**NEDO-33284**

**Revision 1**

**Licensing Topical Report**  
**Marathon-5S Control Rod Assembly**

**Diagram of Lateral and Axial Friction Loads on the Control Rod (Control Rod Lean Exaggerated)**

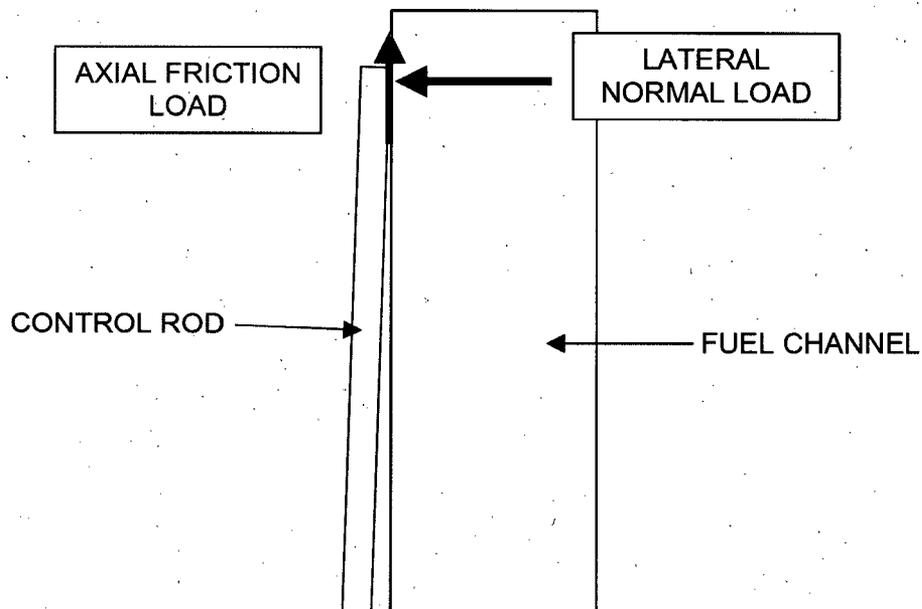
In section A-1.4, a “conservatively estimated” maximum added friction force of [[ ]] is stated.

a,b,c,d) Lateral loads on the handle rollers were determined during testing of alternate roller materials. The tests showed that the lateral loads on the rollers were small, typically between [[ ]], with a maximum of [[ ]]. To determine the axial friction load at this contact, the lateral load is multiplied by a friction coefficient between stainless steel and zircaloy (fuel channels) of [[ ]] (see Figure below). This results in a maximum axial friction load of [[ ]]. For conservatism, this load is rounded up to [[ ]].

#### RAI #21

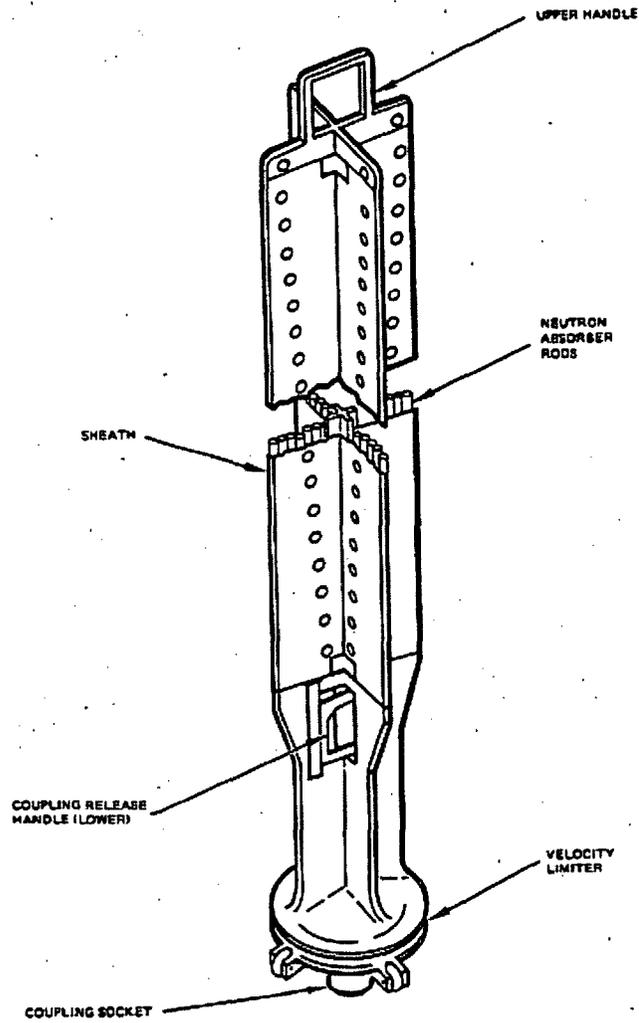
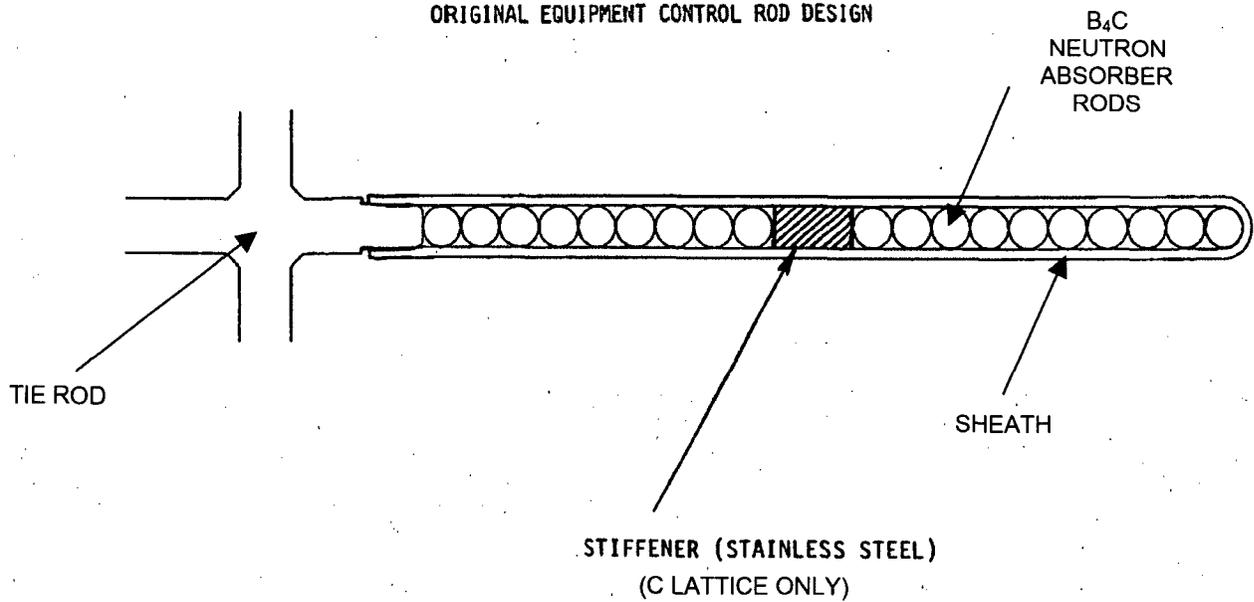
In section 2.2 there is a discussion which indicates that due to the new capsule dimensions, there is slightly less B<sub>4</sub>C powder mass in each capsule (a trade-off to increase mechanical lifetime). In Tables 4-5, 4-6, and 4-7 there is an increase in initial reactivity worths listed (except for cold conditions in the S lattice).

- a. Please discuss how the initial reactivity worth was increased while decreasing the amount of B<sub>4</sub>C contained in each capsule.
- b. Please provide either a brief description of the OE equipment and/or reference, to further clarify the nuclear calculations, which compares OE and Marathon-5S initial reactivity worths. This is needed to verify that the MCNP input deck geometries are correct. In particular, dimensions for the sheath, the stainless steel block in the middle of the CRB wing, and the absorber rods as modeled in MCNP should be provided.
